**MADERA UNIFIED  
SCHOOL DISTRICT**  
1902 Howard Road  
Madera CA 93637  
(559) 675-4500  
(559) 675-1186 Fax  
[www.madera.k12.ca.us](http://www.madera.k12.ca.us)

Addendum No. 1-Bid Section 1-5  
Asphalt Resurface & Repairs at Various School Sites  
BID No. 033116

This Addendum is attached to and made a part of the above entitled specifications for Madera Unified School District for BID No. 033116 with a due date of May 5, 2016

Adams Elementary alley/lot view 2

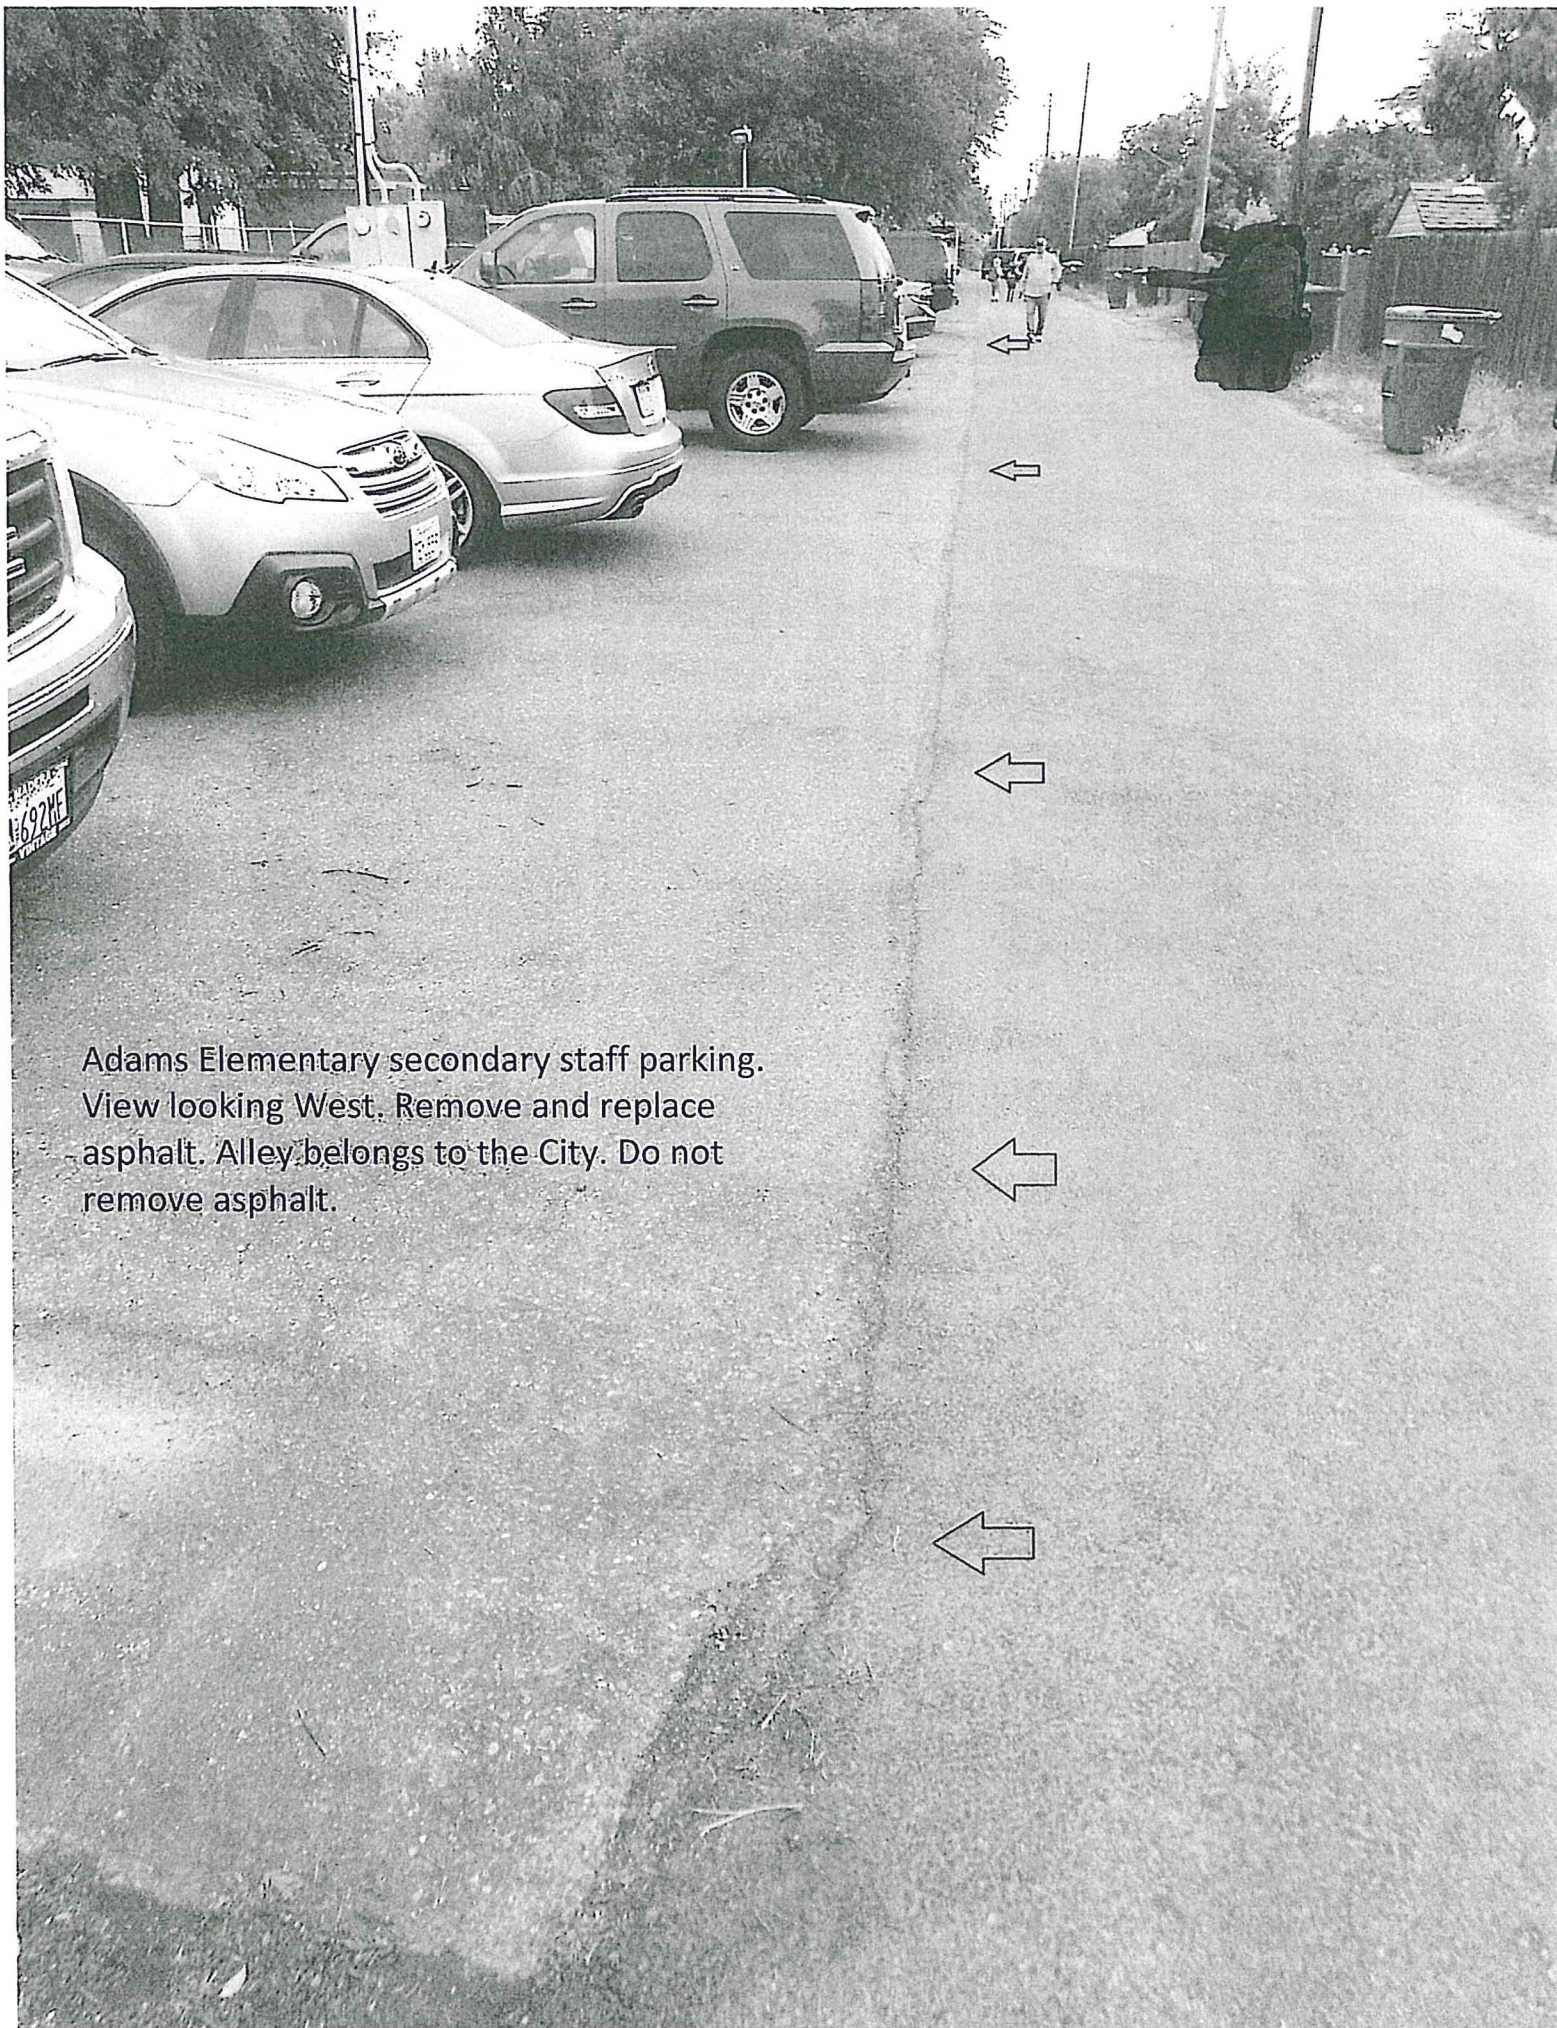
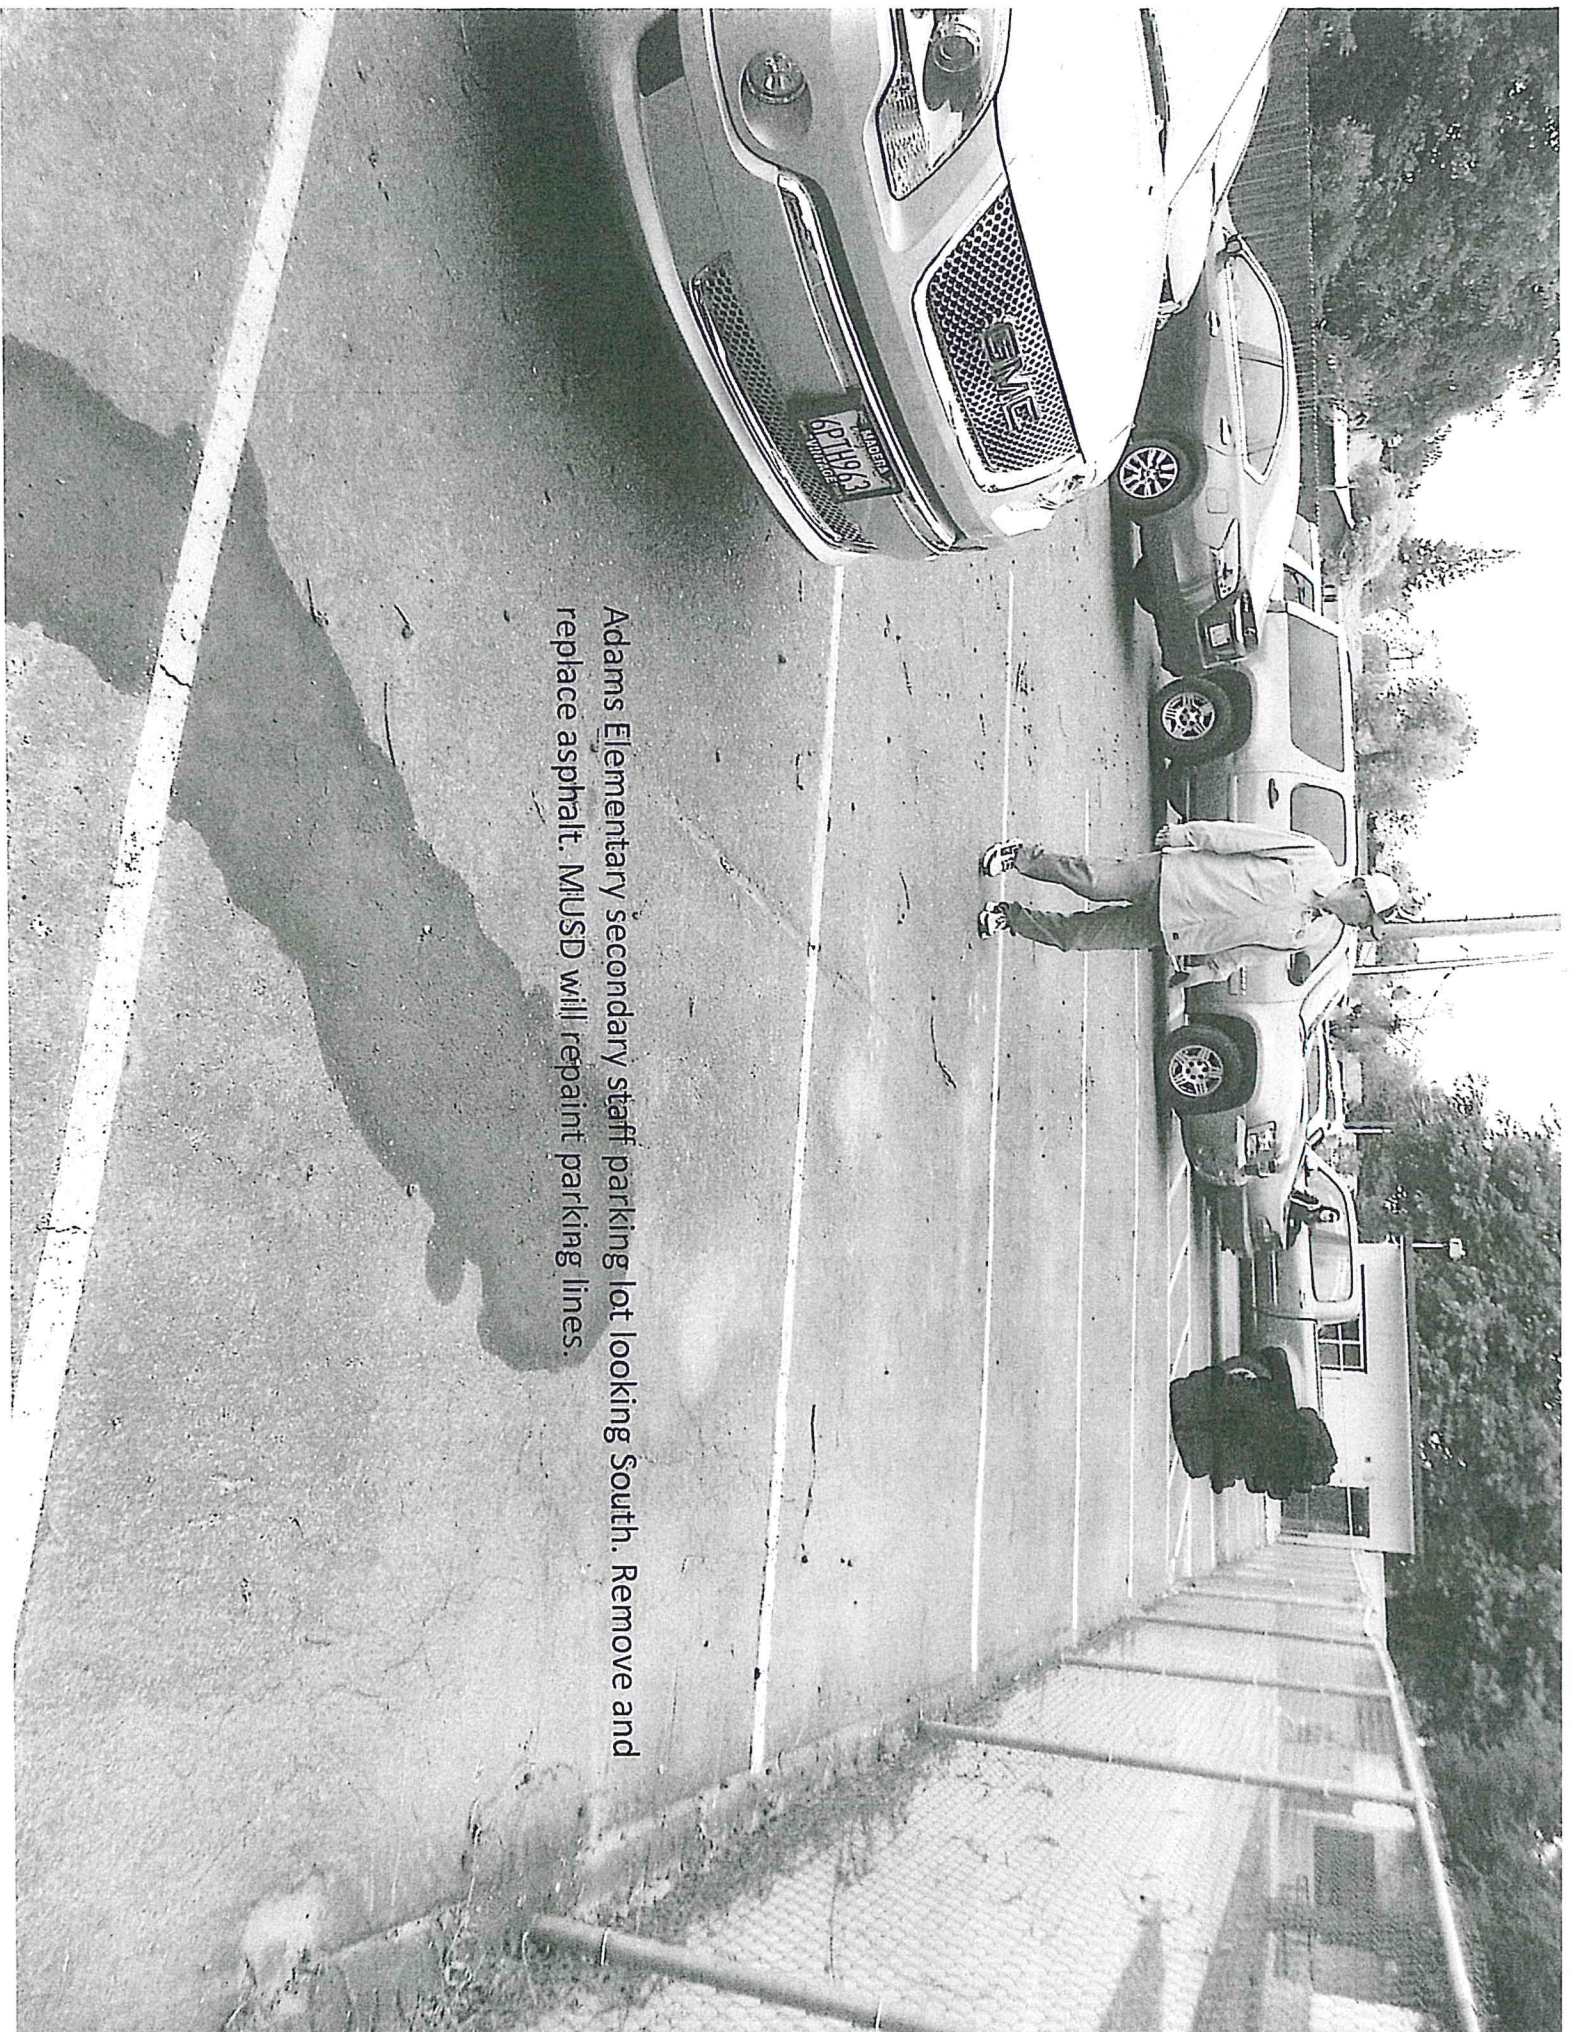
Adams Elementary secondary staff parking.  
View looking West. Remove and replace  
asphalt. Alley belongs to the City. Do not  
remove asphalt.

Adams Elementary secondary staff parking lot looking South. Remove and replace asphalt. MUSD will repaint parking lines.

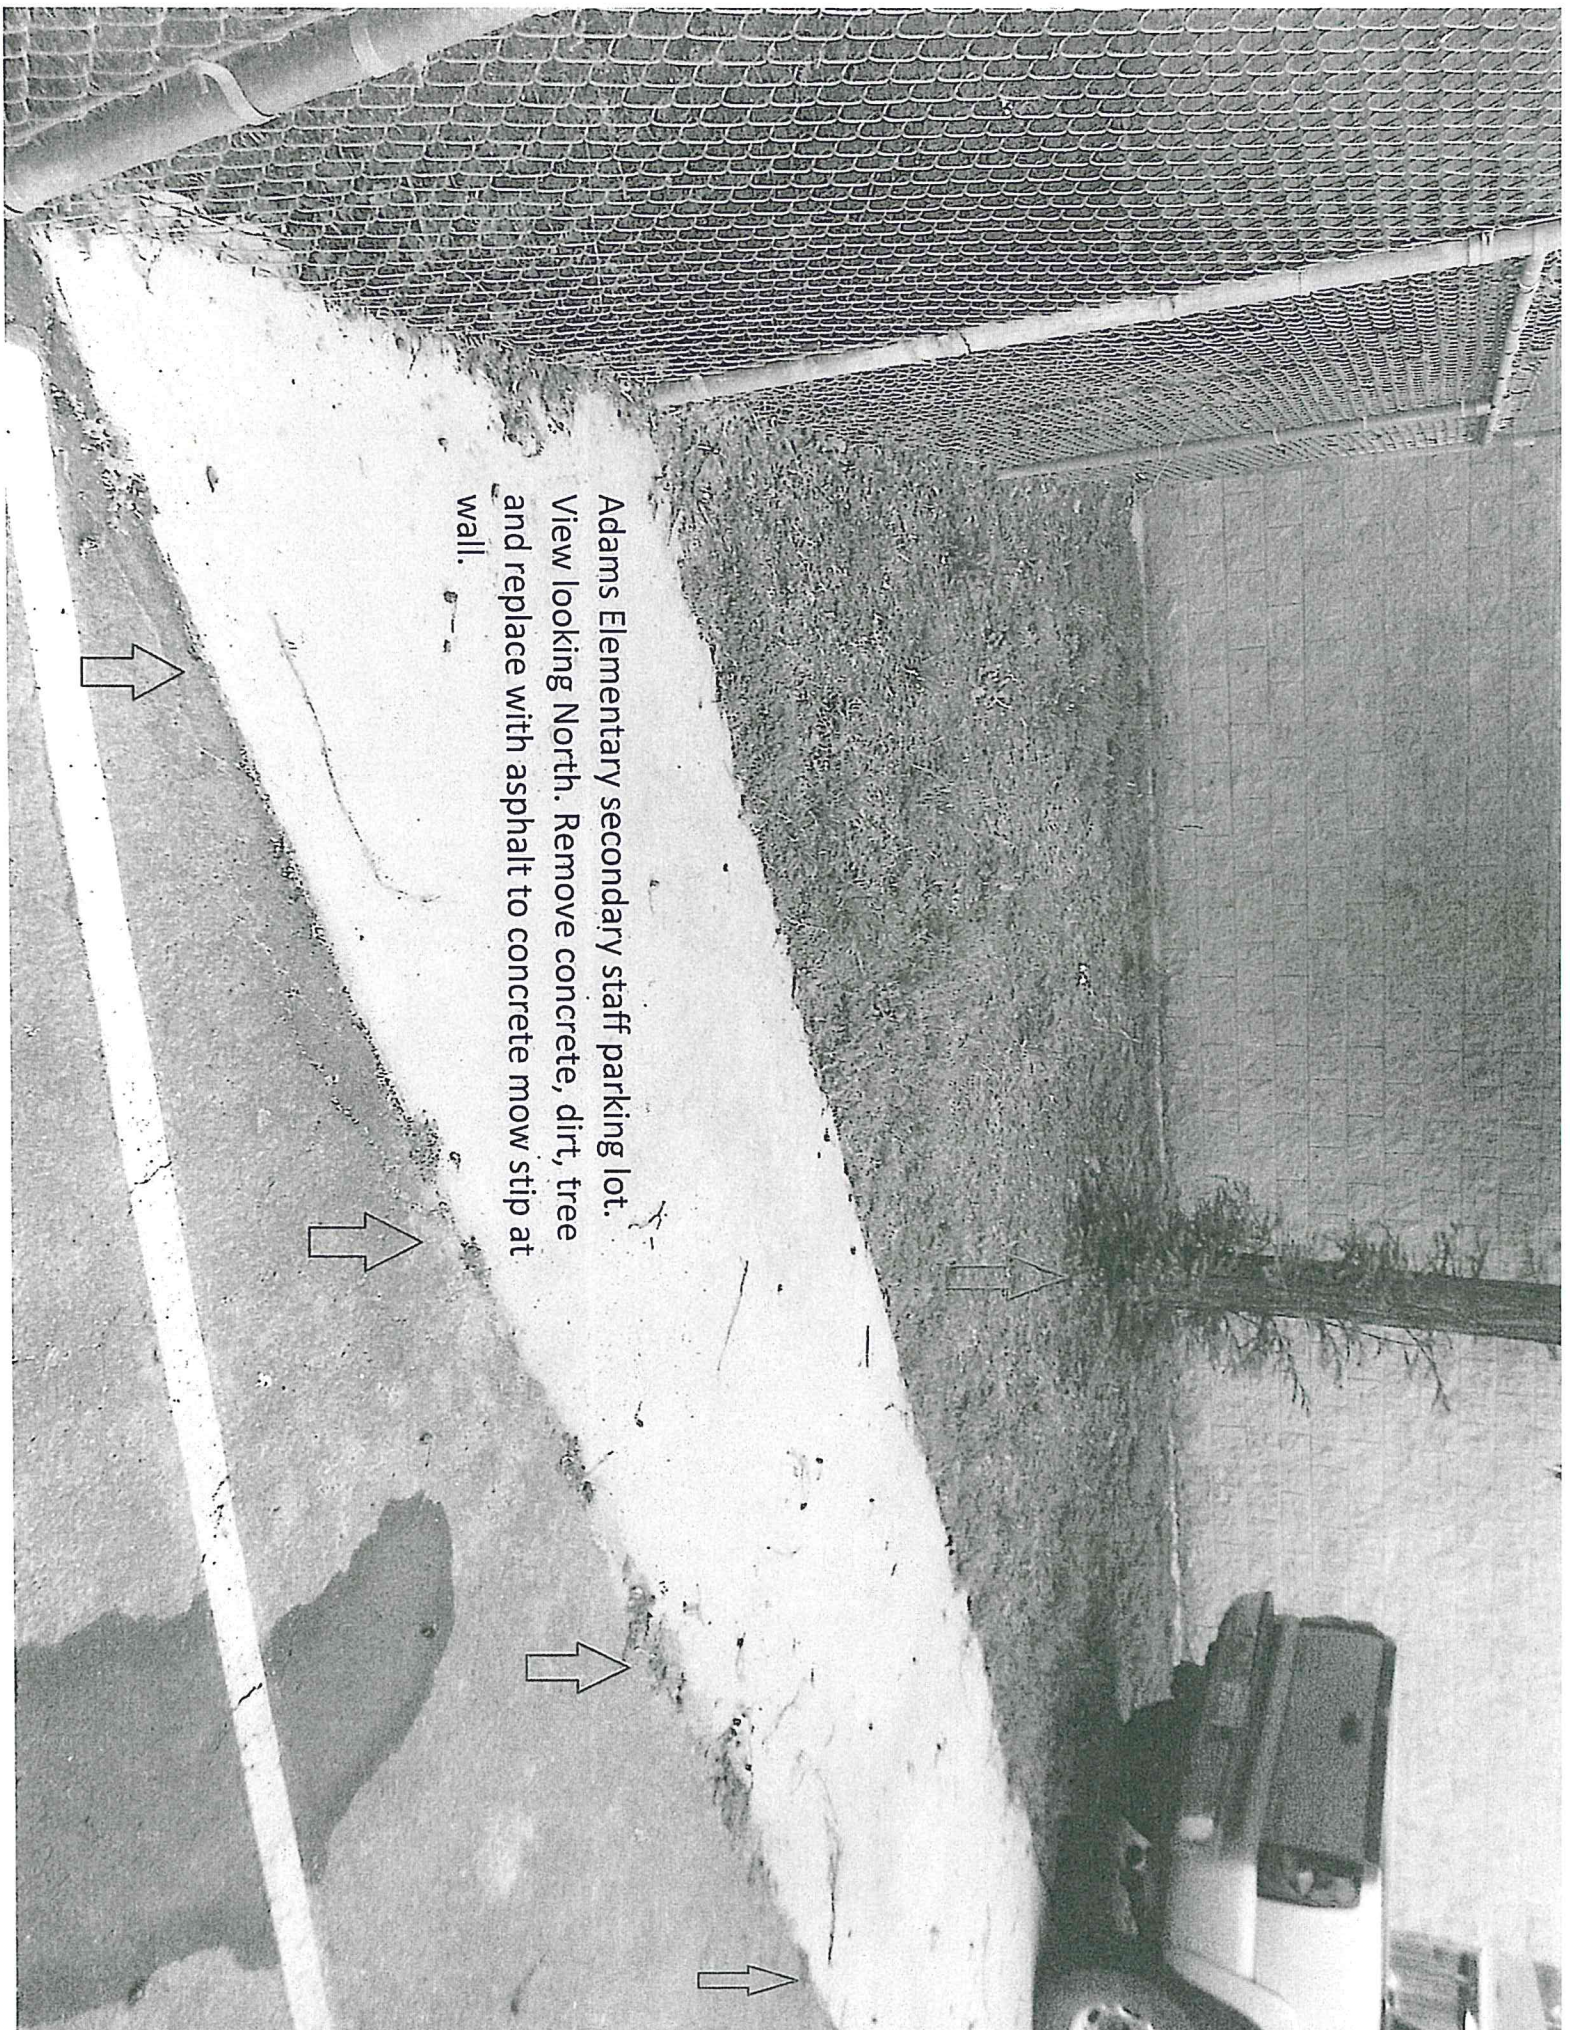
Adams Elementary secondary staff parking lot.  
View looking North. Remove concrete, dirt, tree  
and replace with asphalt to concrete mow strip at  
wall.

Adams Elementary secondary staff  
parking lot. Remove concrete, dirt, tree  
and replace with asphalt. Add concrete  
mow strip to new asphalt.

New concrete  
mow strip
